ADDENDUM 2 – JOB 29

TO: All prospective bidders on project ITS-9-999(344) & SS-9-999(339), Job No. 29, scheduled for the October 9, 2015 bid opening.

Projects: ITS-9-999(344) (PCN-20969) and SS-9-999(339) (PCN-20898)

2015 ESS & ATR IMPROVEMENT - WEST

ATR & ESS Details
Various Sites

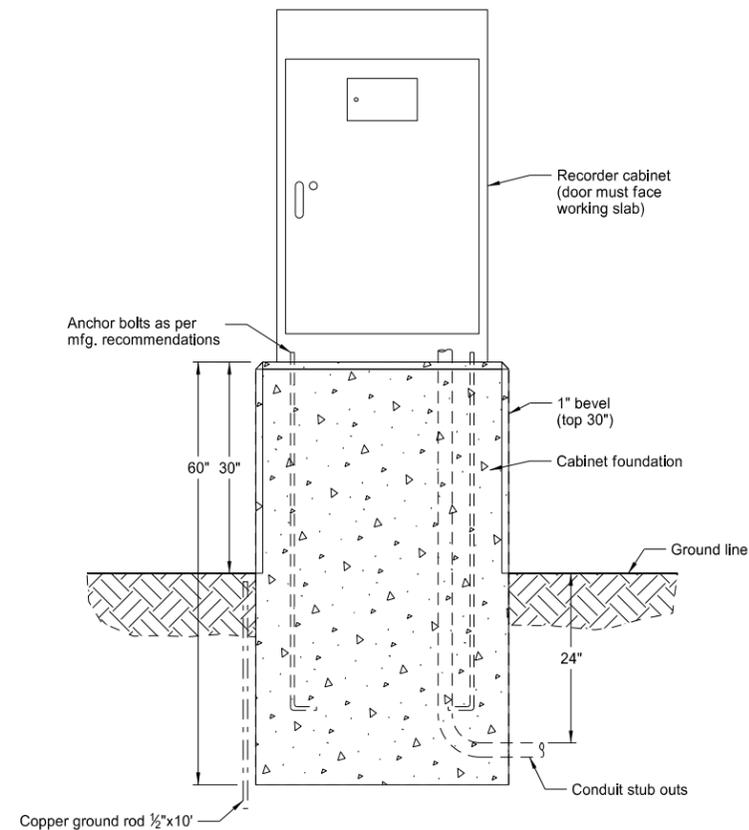
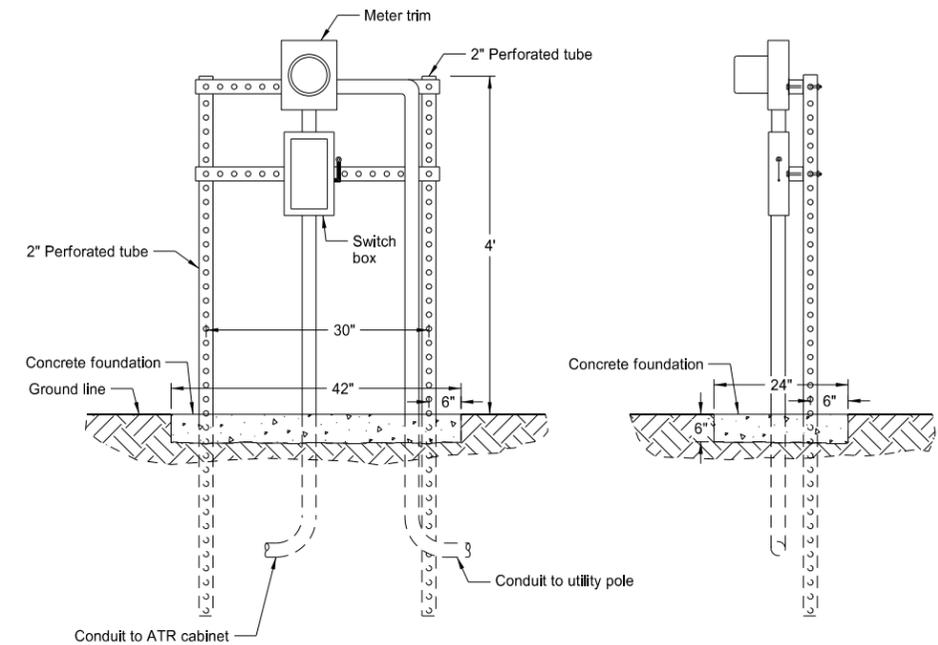
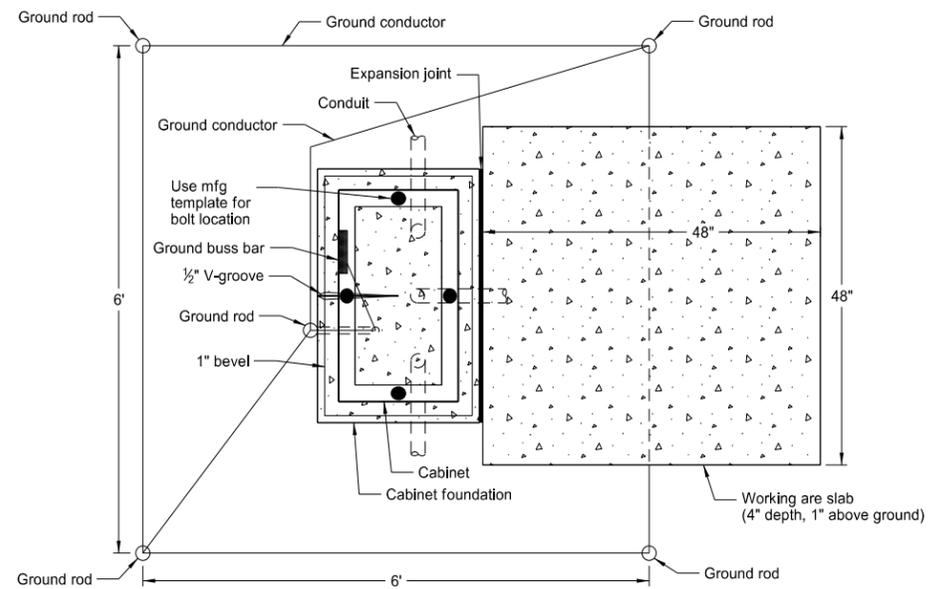
Sheet 150-25:

The detail showing a control cabinet with a switch box has been removed.
